**MAJOR PROJECT ASSESSMENT:  
Warehouse and Distribution Centre  
Development, Lenore Lane,  
Erskine Park**

Director-General's  
Environmental Assessment Report  
Section 75I of the  
*Environmental Planning and Assessment Act 1979*

February 2007

Figure 4: Existing and Proposed Creek Alignments

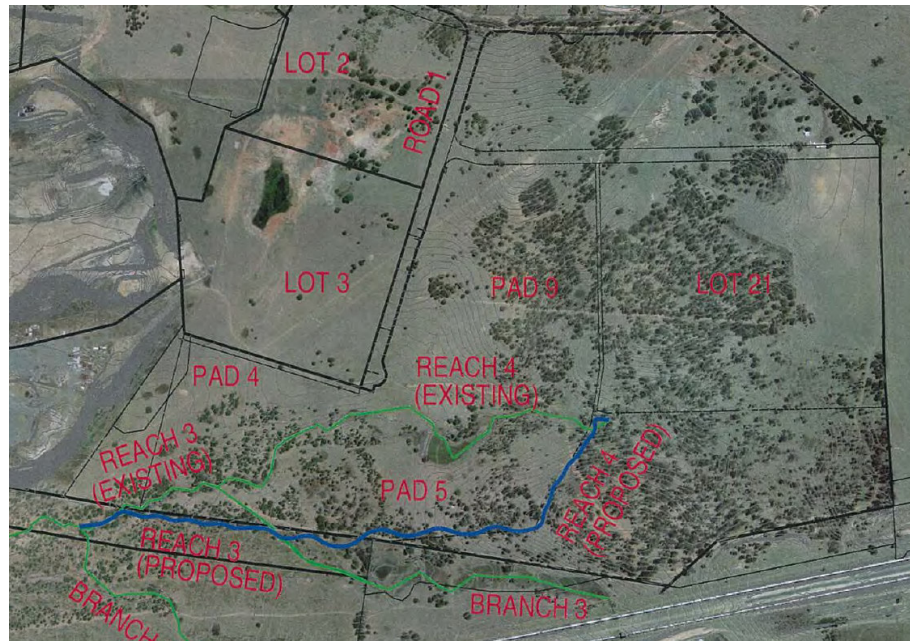
The submission from Jacfin (a nearby landowner) raised various concerns regarding water related impacts associated with the proposal and engaged the services of Dr Stephen Webb, an engineer and hydrologist, to review the stormwater concept plan and creek realignment. Primarily, Jacfin considers that the EA did not contain sufficient information for a detailed assessment of flooding impacts to be undertaken. The key issues raised in Jacfin's submission include:

- whether the channel would be described as a watercourse under the *Rivers and Foreshore Improvement Act 1948* (RFI Act); and
- the likely increase in flooding impacts on Jacfin's adjacent property (Lot 11 DP 229784) as a result of the realigned creek and the adequacy of the assessment of flooding impacts, including;
  - the lack of detail regarding the design of the channel;
  - the adequacy of the location and sizing of detention basins; and
  - inadequate details relating to water quality treatment of stormwater and the maintenance of the riparian corridor.

Concerns raised by Jacfin regarding off site flooding impacts of the proposal predominantly relate to the relocation of the creek. CSR is proposing to relocate the creek within 10 to 15 m of the northern boundary of Jacfin's property. Modelling undertaken by CSR indicates that there would be a net increase in the flood extent on Jacfin's property. This increase predominantly relates to smaller storm events, with the 2 year events resulting in an increase in the flood extent of 353m<sup>2</sup>, or an additional 3.6% of area impacted on Jacfin's property. A 100 year event would result in a minor increase in the flood extent of 74m<sup>2</sup>, or an additional 0.5% of area impacted on Jacfin's property. While impacts are

considered localised and minor in nature, the Department concurs with Jacfin that all impacts should be contained within CSR's site and there should be no impacts off site.

The Department is confident that engineering solutions would be available to reduce these impacts and can be fully described during the detailed design of the creek realignment and stormwater management system. In addition, the Department considers that any residual impacts on Jacfin's property would be mitigated through the recommended conditions of approval which require CSR to:

1. revise the streamworks design concept (including the location of the realigned creek in the vicinity of Jacfin's property) and demonstrate there is no increase in the flood extent on Jacfin's land and to reduce the risk of creek accretion into Jacfin's land;

2. prepare and implement a creek realignment plan, including:
  - details of the management of streamworks including detailed plans and procedures for the commissioning of the creek;

- details of the establishment and management of a riparian zone for the realigned creek;
  - a program for the monitoring and maintenance of the realigned creek; and

- contingency plan to respond to any failures of the realigned creek;
3. commission an independent audit of the realigned creek once completed to ensure works have been carried out in accordance with the creek realignment plan; and

4. to prepare and implement a stormwater management plan detailing the stormwater management scheme, performance criteria for the scheme and the maintenance and monitoring procedures for the scheme.

Figure 5: Biodiversity Corridor identified in the Biodiversity Management Plan

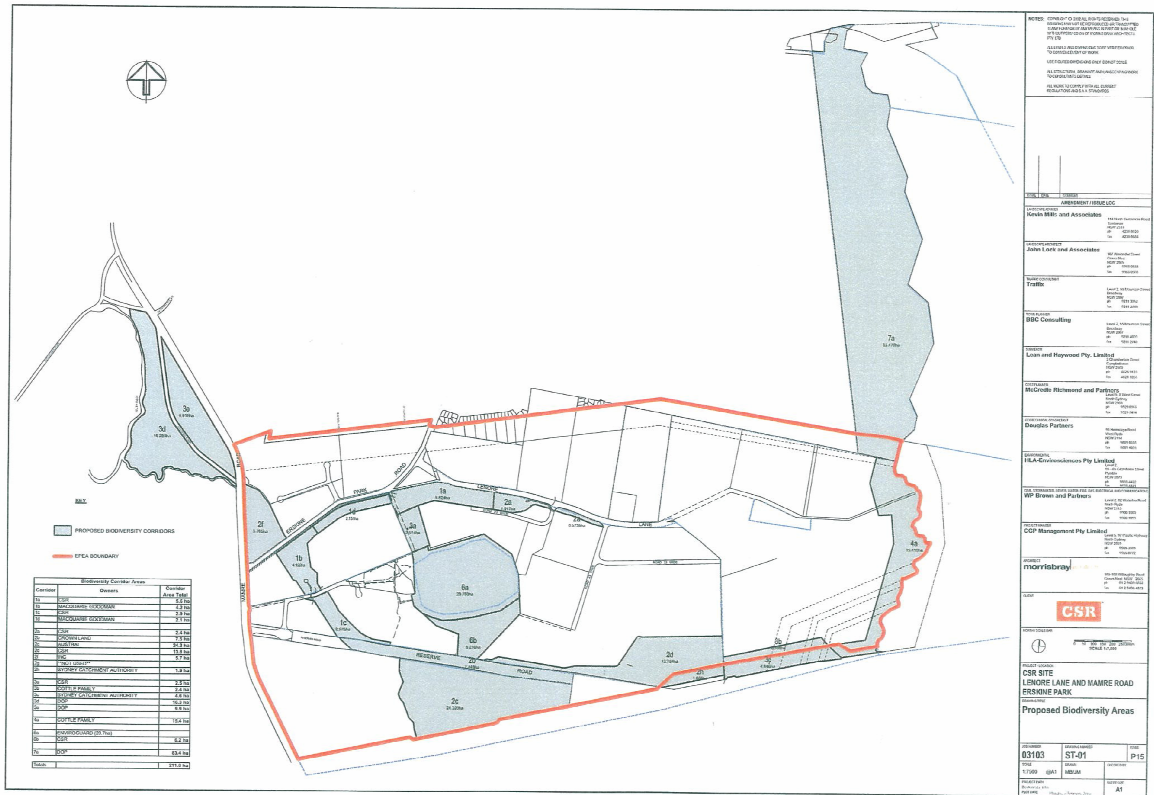
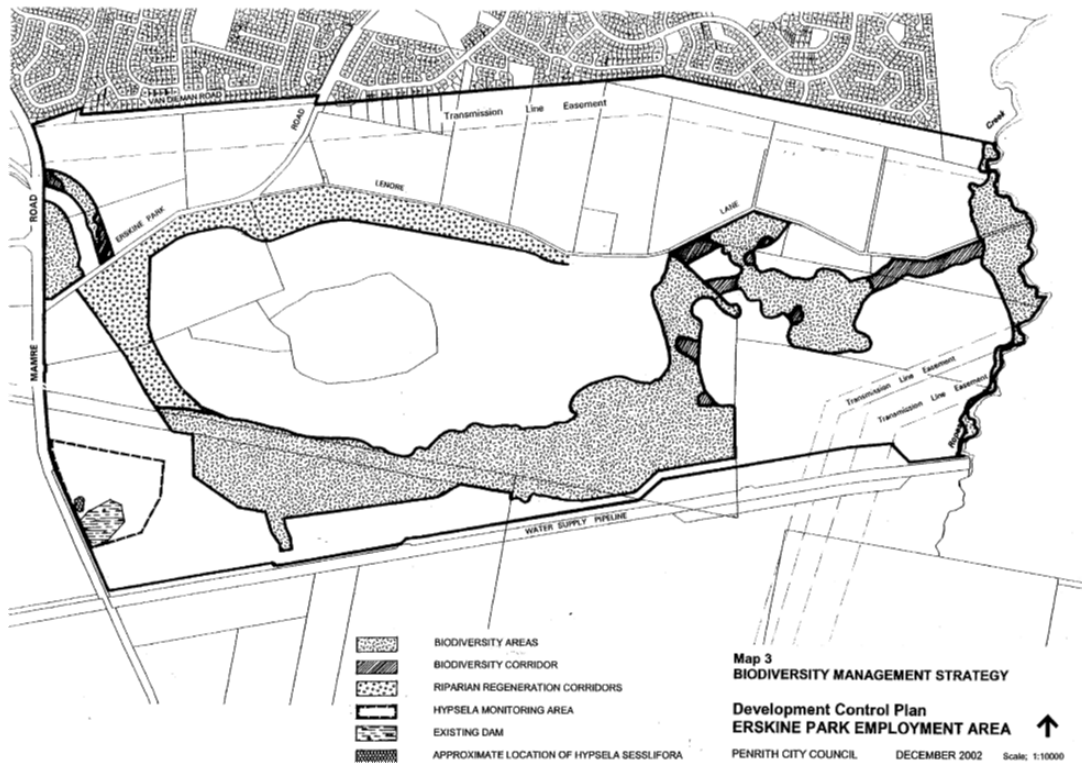
The submission from Jacfin initially raised concerns that the proposal would involve the removal of large portions of vegetation identified in the Penrith DCP as biodiversity corridor, which is a significant non-compliance with the DCP and that it was not possible to assess the justification for this non-compliance as the *Biodiversity Strategy 2005* and BMP were not exhibited with the proposal. A copy of the BMP which includes the *Biodiversity Strategy 2005* was subsequently provided with CSR's response to submissions and the response was made available to the public on the Department's website.

Jacfin subsequently raised concerns that the land identified for conservation in the BMP is less than that identified for conservation in the revised DCP. Additionally, Jacfin also raised concerns that even though Council has recently released the Penrith DCP 2006, sections relating to biodiversity conservation within the EPEA had not been updated to reflect the BMP.

The BMP has support from the Department, DEC, Council and Greening Australia, and neither the DEC nor Council raised any specific concerns regarding the CSR proposal. It is noted that the preparation of the BMP is a separate process to CSR's proposal. Council has been heavily involved in the preparation of the BMP and the Department understands that following the endorsement of the BMP by the Minister, Council will incorporate the relevant biodiversity information into the DCP.

The Department is satisfied that any inconsistencies with the DCP relating to biodiversity have been justified. Additionally, the Department and DEC are satisfied that the proposal is consistent with the BMP. Notwithstanding, to ensure that the BMP is acted upon, the Department's recommended conditions of approval require CSR to enter into the abovementioned voluntary planning agreement with the Corporation prior to the construction of Stage 1. The Department is therefore ensuring that CSR will contribute to the broader aim of establishing a biodiversity area and management regime across the EPEA.

Figure 7: Access Options to Jacfin's Property

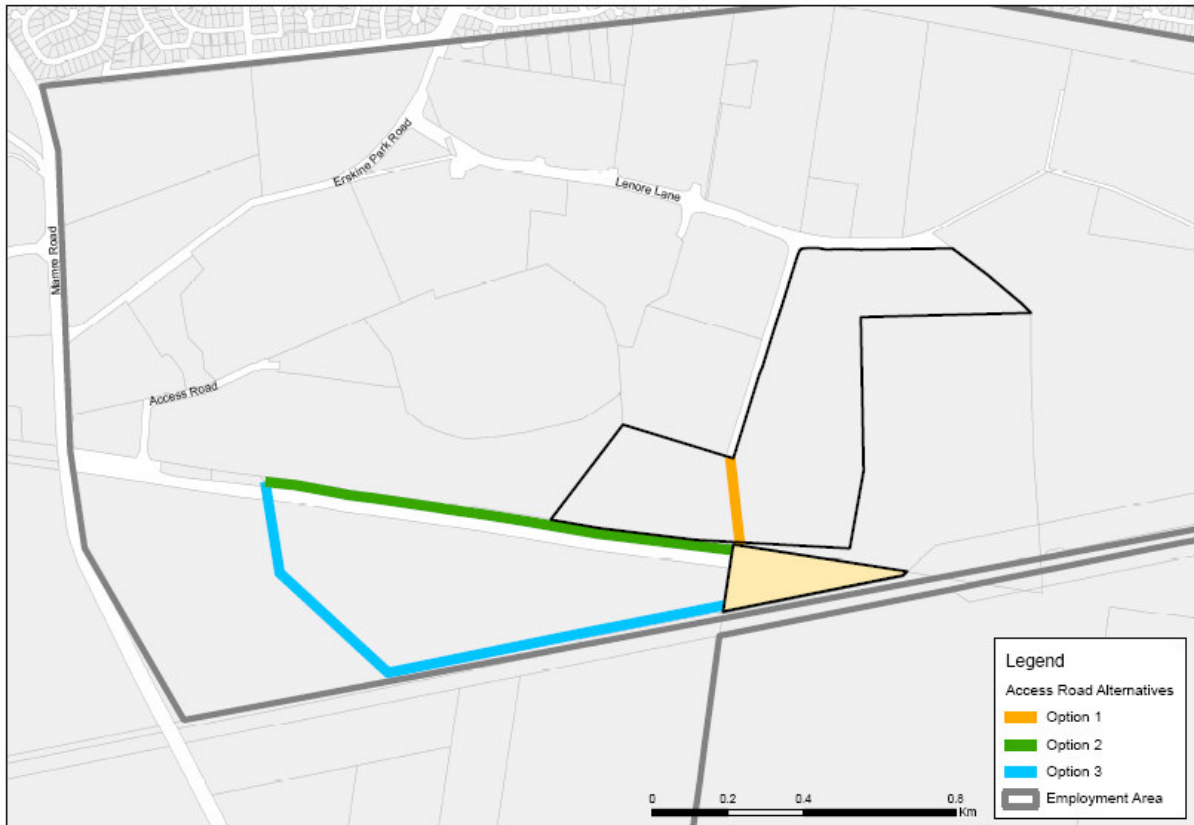
Jacfin claims that the proposal would sterilise its only access to Lot 11 DP 229784 (a Jacfin site) by locating part of the proposed creek realignment in the Crown road reserve, and including the reserve in the proposed biodiversity corridor.

While Jacfin acknowledges that the proposal would provide an alternate option for securing access to its property it argues that CSR should be required to pay the cost associated with constructing the bridge over the proposed creek realignment as the need for a such a bridge is a direct consequence of the proposal.

At present, the only access to Jacfin's property is via the Crown road reserve (option 2 on Figure 7). The proposal would use at least 25 metres of the 60 metre wide reserve for the creek realignment works. However, the Department does not accept that these works would sterilise Jacfin's only access to its property as at least 35 metres of the reserve would be available, which is more than adequate for an access road to the property.

In addition, the Department does not accept Jacfin's claim that the inclusion of the Crown road reserve in the proposed biodiversity corridor would effectively extinguish Jacfin's right to build on this road reserve. The conservation value of the vegetation on the Crown road reserve is significant regardless of whether it is part of the biodiversity corridor or not, and it is important to note that this road reserve was already included in the biodiversity corridor for the EPEA identified in the Penrith DCP (see Figure 6). In other words it was, and will remain, difficult to secure approval for the construction of a road within the reserve, particularly since the DEC and Council support the conservation of the vegetation within this reserve. However, it is important to note that this was the case before the proposal, and that this proposal will not alter the status quo. Consequently, the Department is satisfied that Jacfin's ability to access its property would not be significantly affected by this proposal.

In fact, the proposal would improve the accessibility of Jacfin's property, as it includes the provision of an easement to the Jacfin property via a corridor from the end of Templar Road (option 1 on Figure 7). This corridor would be approximately 120m long, as opposed to the corridor through the Crown road reserve which is approximately 900m. The Department considers that the proposal provides an additional access route to Jacfin's property and a more feasible option for access.

There is a third option for access to Jacfin's property, which is shown as a possible link in the Penrith DCP (option 3 on Figure 7). However, this route traverses land owned by Macquarie Goodman Management (otherwise known as Austral Bricks). Macquarie Goodman Management is currently seeking approval to utilise this land for storage and distribution purposes and therefore this land would not be available for an access road. It is noted that the access route was never formalised in the DCP and is not covered by Council's development contributions plan for the EPEA. Additionally, Council has no intention of acquiring this land to construct a road. Therefore, this option is not considered a viable option for access to Jacfin's property.

The Department and Council do not support this argument. The road to Jacfin's property, whether it be built through the Crown road reserve or through CSR land is only required for the development or use of the Jacfin land, and should be paid for by Jacfin. Both roads would need bridges (or similar), and the fact that Jacfin would need to construct a bridge over CSR's proposed creek realignment is an irrelevant consideration to the CSR proposal and is simply an economic cost associated with the use of CSR's land to secure access to the Jacfin land. In fact, based on preliminary estimates, the Department understands that it would be significantly cheaper for Jacfin to construct the access road on CSR's land (including the cost of the construction of a bridge) than it would be to construct an access road through the Crown road reserve.

Consequently the Department is satisfied that the proposal would not sterilise Jacfin's access to its land. If anything, the proposal would greatly improve the accessibility of the land and provide a cheaper option for securing access to Jacfin's property regardless of the need to construct a bridge.
